DESIGN REVIEW

4721 38th Ave SW
Seattle, WA 98116

April 19, 2018 | SDCI #3028047

LIVE/WORK SIGNAGE

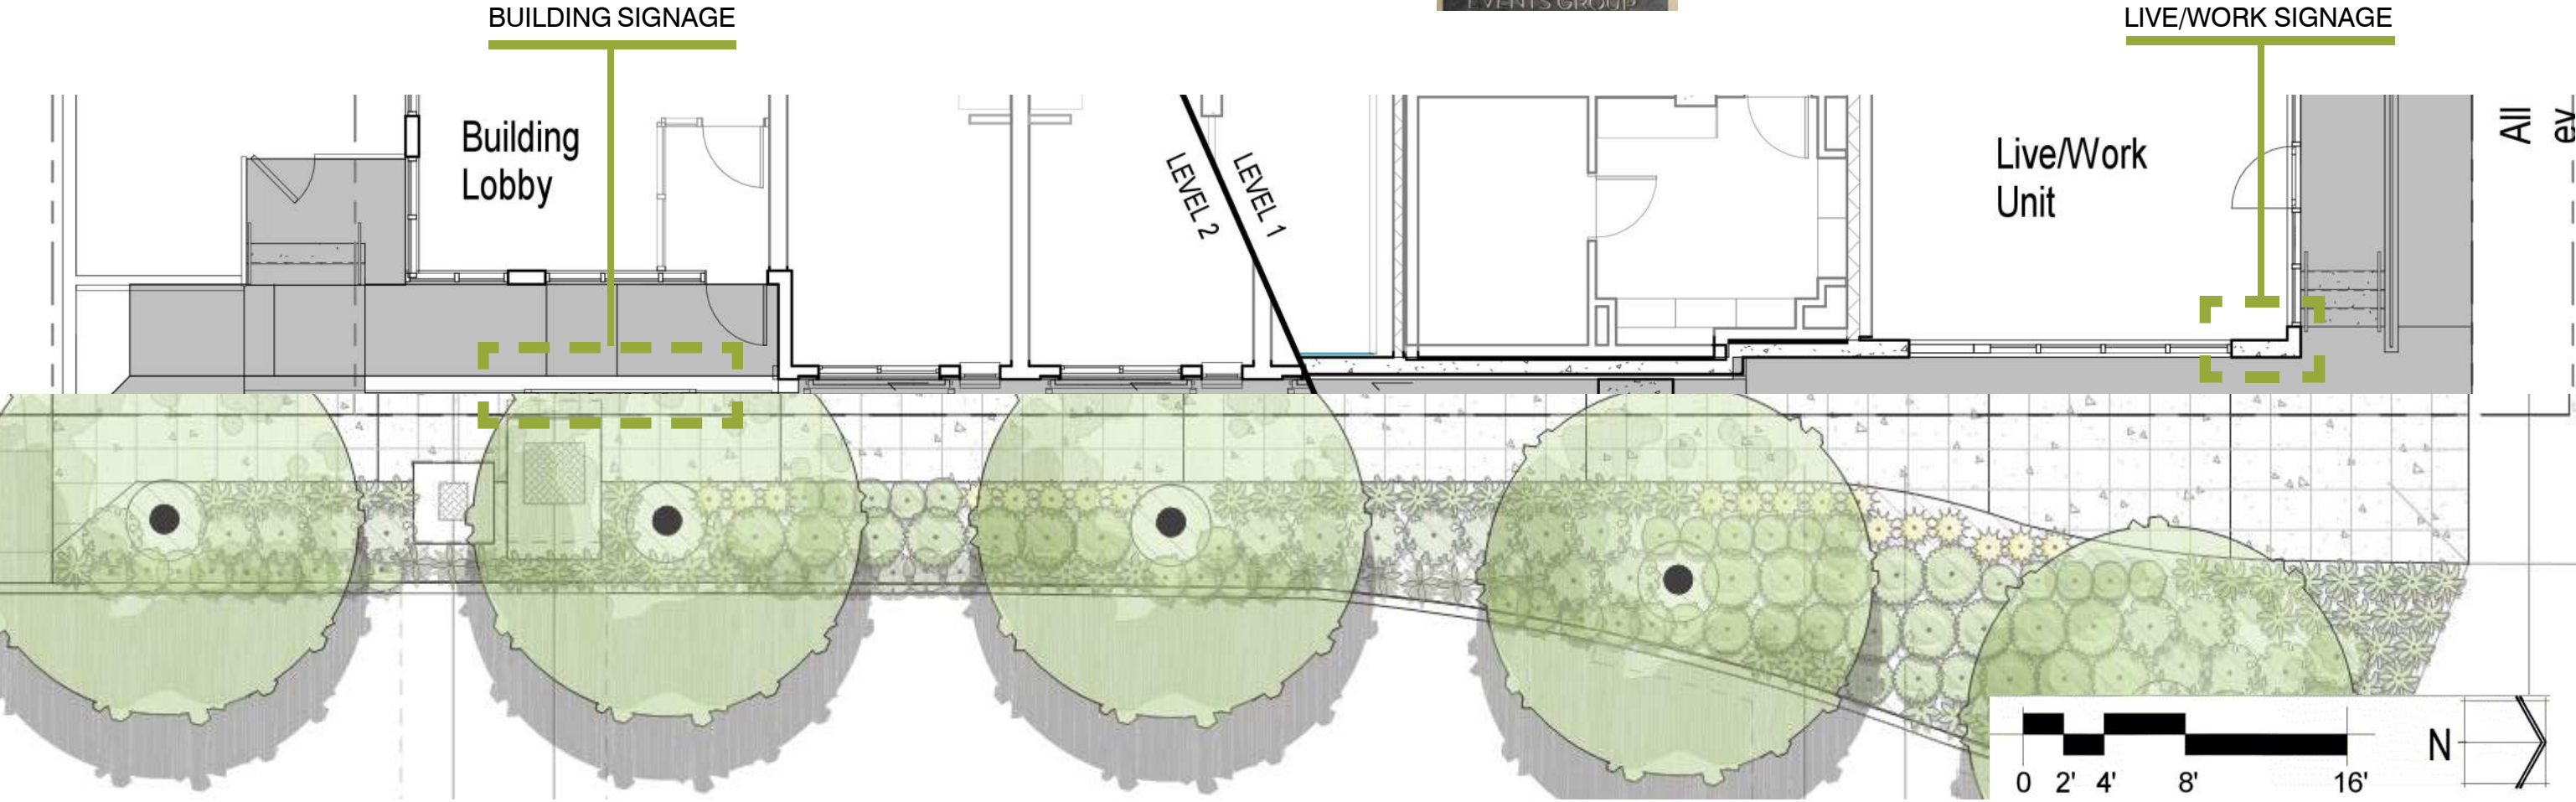
1g. The Board requested that a conceptual signage plan be presented, with special attention paid to scale and character to add human scale along Fautleroy Way SW. (DC4-B-1 Scale and Character)

Response: The conceptual signage plan includes both building and live-work signage at pedestrian eye-level, providing an appropriate scale consistent with the residential character of 38th Ave SW.

DEPARTURE DIAGRAM 1 - STREET LEVEL FACADE

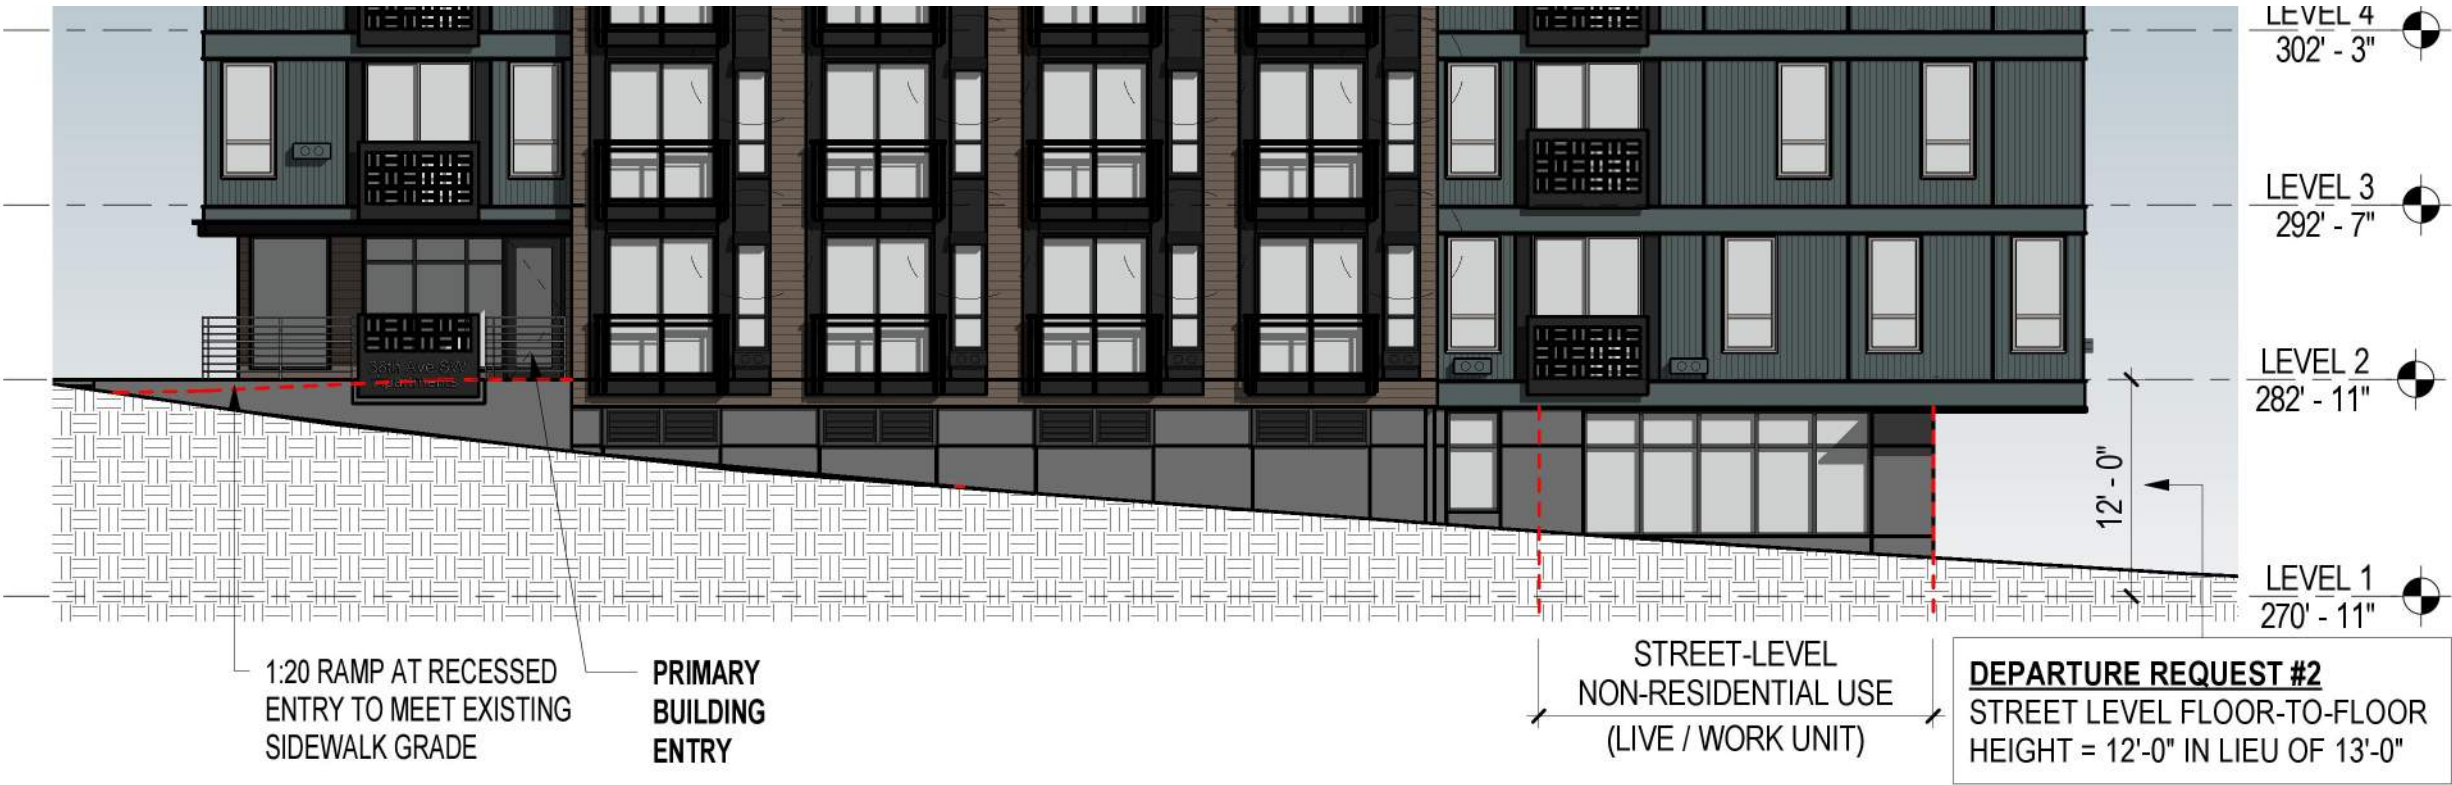
DEPARTURE REQUEST #1 – Parking Location Within a Structure

- Standard: *SMC 23.47A.032.B.1.b – Location of parking within a structure: Street-level parking shall be separated from street-level, street-facing facades by another permitted use.*
- Proposed Design Departure: To allow a small portion of the first floor parking garage to be adjacent to the street-level, street-facing façade.
- Rationale:
 - Due to the sloped sidewalk condition, the portion of the garage in question is mostly below grade. Only a small portion, 51 square feet in area, will be next to the street (DC2-A-1 Site Characteristics and Uses).
 - The portion next to the street is less than six feet high, and will contain no windows. It will not be perceived as part of the parking use of the building (DC1-C-2 Visual Impacts of Parking).
 - See Departure Diagram No. 1.

DEPARTURE DIAGRAM 2 - FLOOR-TO-FLOOR HEIGHT

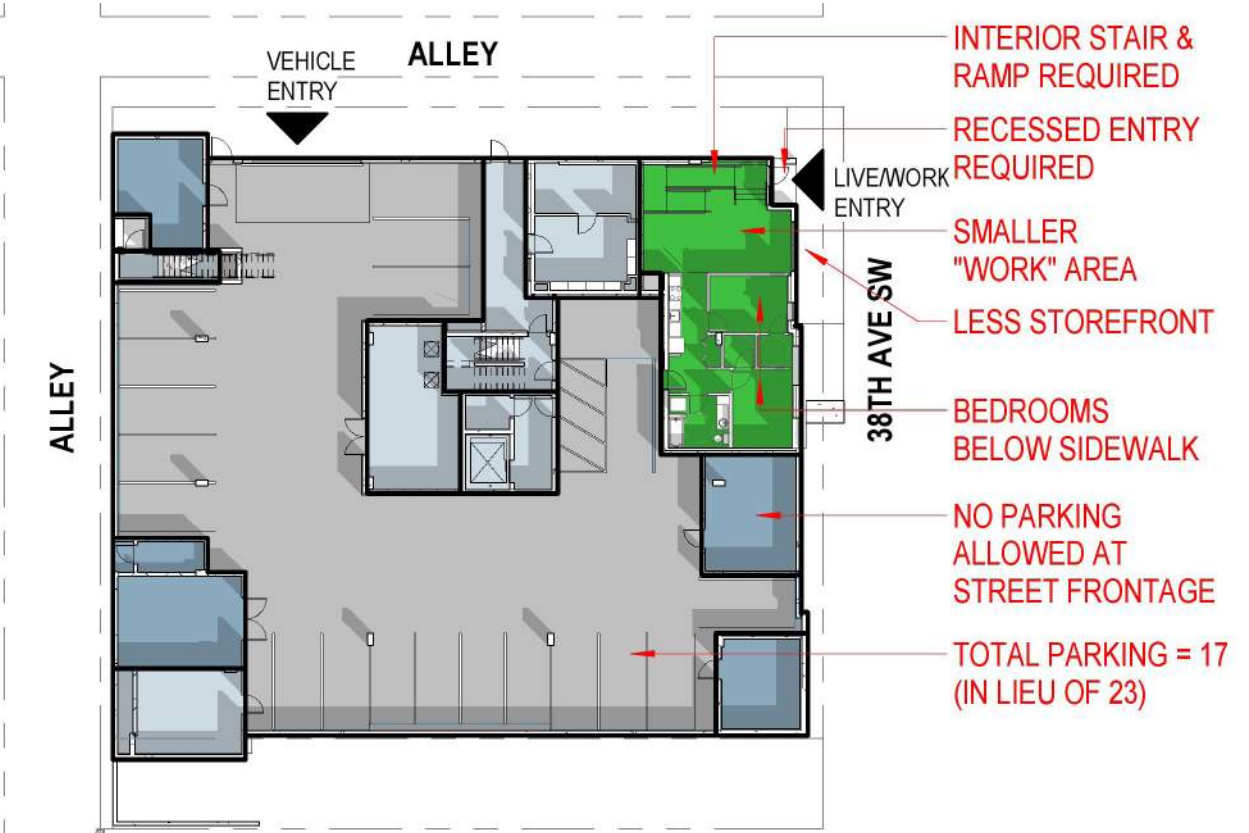
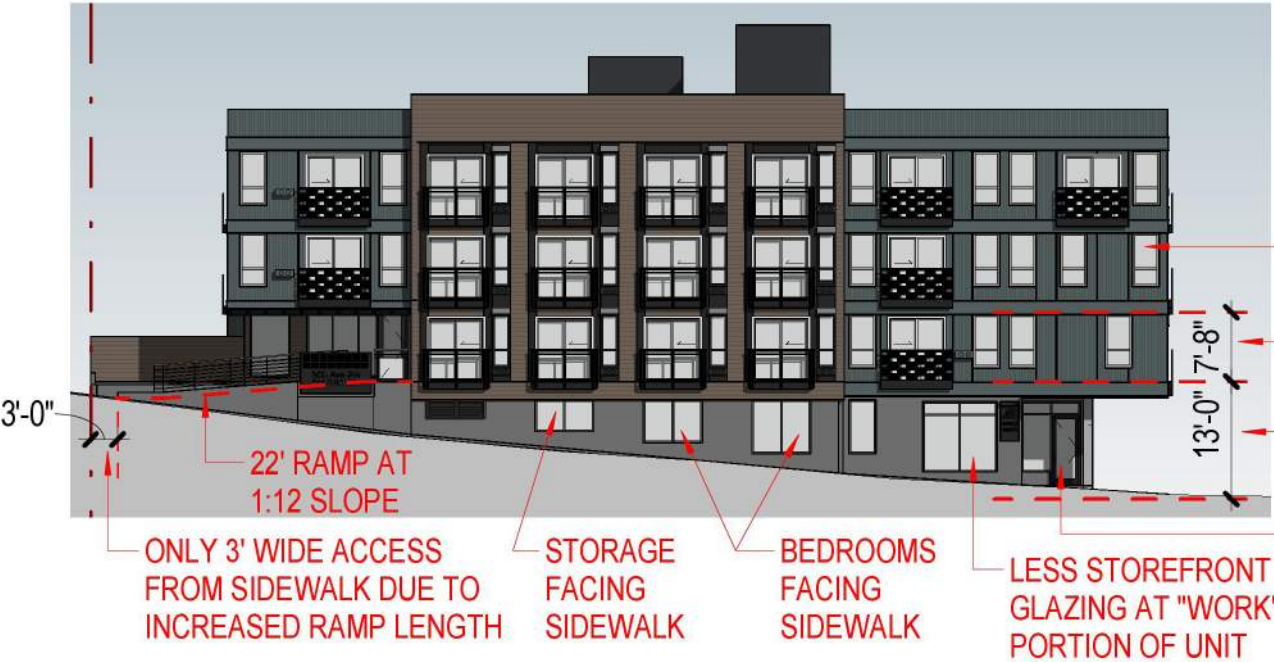
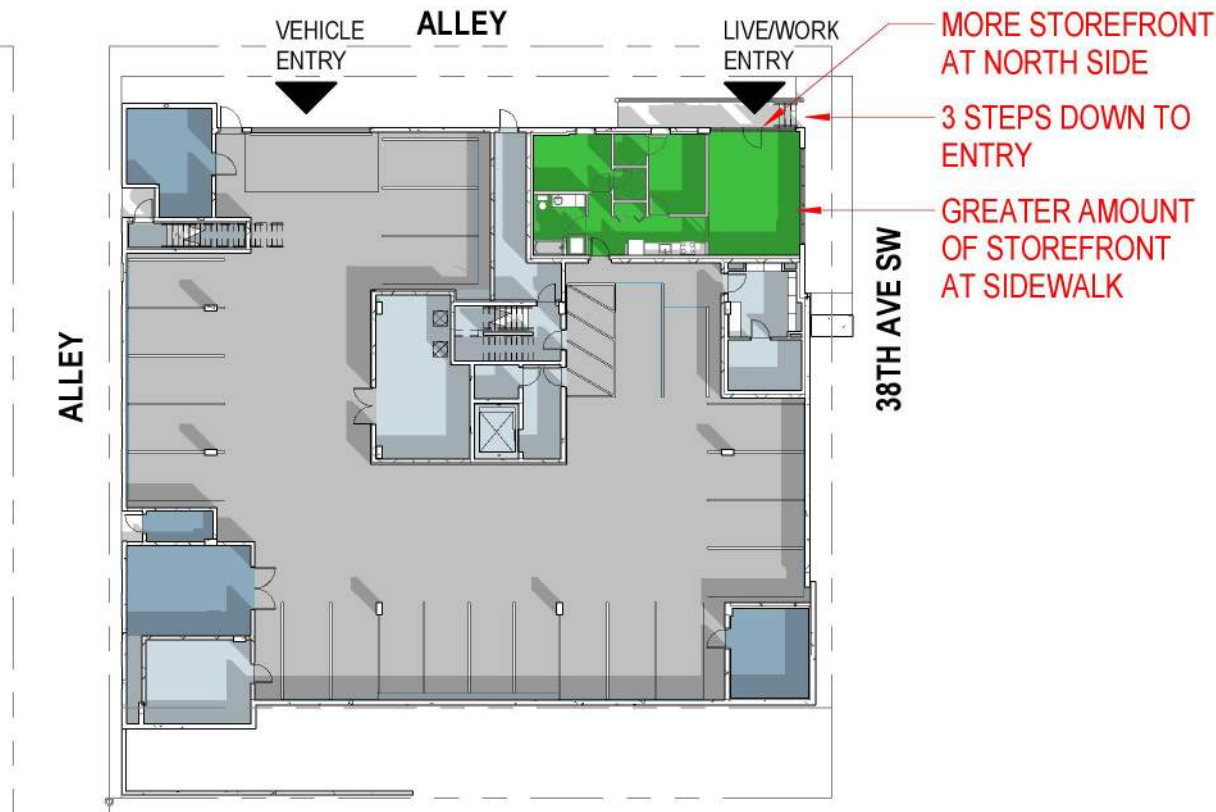
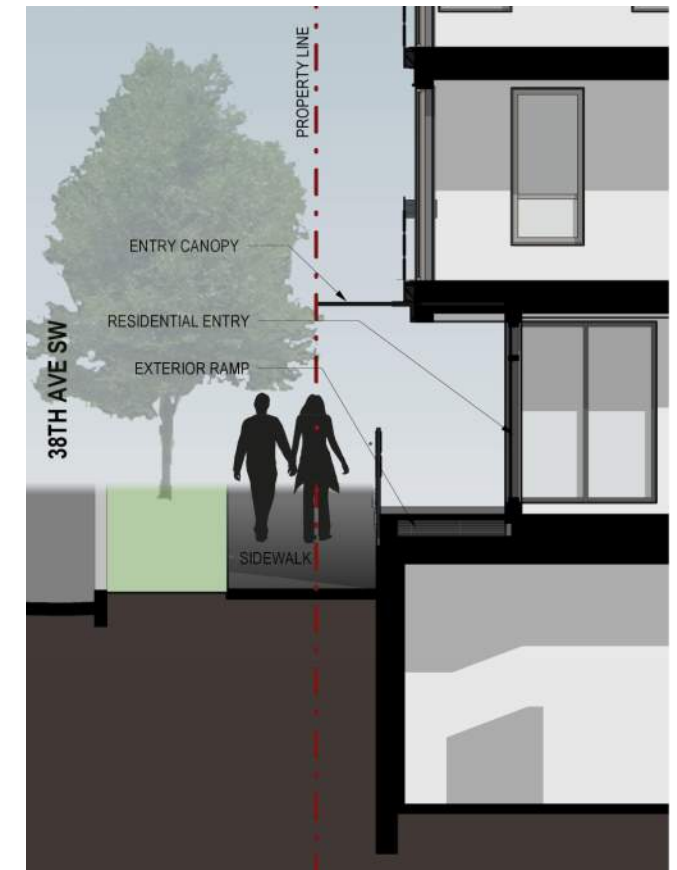
DEPARTURE REQUEST #2 – Street Level Height Provisions

- Standard: *SMC 23.47A.008.B.4 – Height provisions: Non-residential uses at street level shall have a floor-to-floor height of at least 13 feet.*
- Proposed Design Departure: To allow the first level floor-to-floor height to be 12 feet in lieu of the required 13 feet.

- Rationale:
 - Due to the sloped grade at the existing right-of-way, the proposed design includes the primary building entry on the second level, and the live-work unit at the lower level (DC2-A-1 Site Characteristics and Uses).

- A 12 foot floor-to-floor height allows both entries to have a better relationship with the existing sidewalk grade (PL3-1-c Common Entries to Residential Buildings).

- The reduction in floor-to-floor height will not be perceived at the street level façade, since the first level is partially below grade, and actually reduces the overall mass of the building (DC2-a-2 Reduced Perceived Mass).

- The relationship of the residential and live/work entries better relates to the two differing adjacent uses (CS2-D-4 Massing Choices, Transition Between Zones).
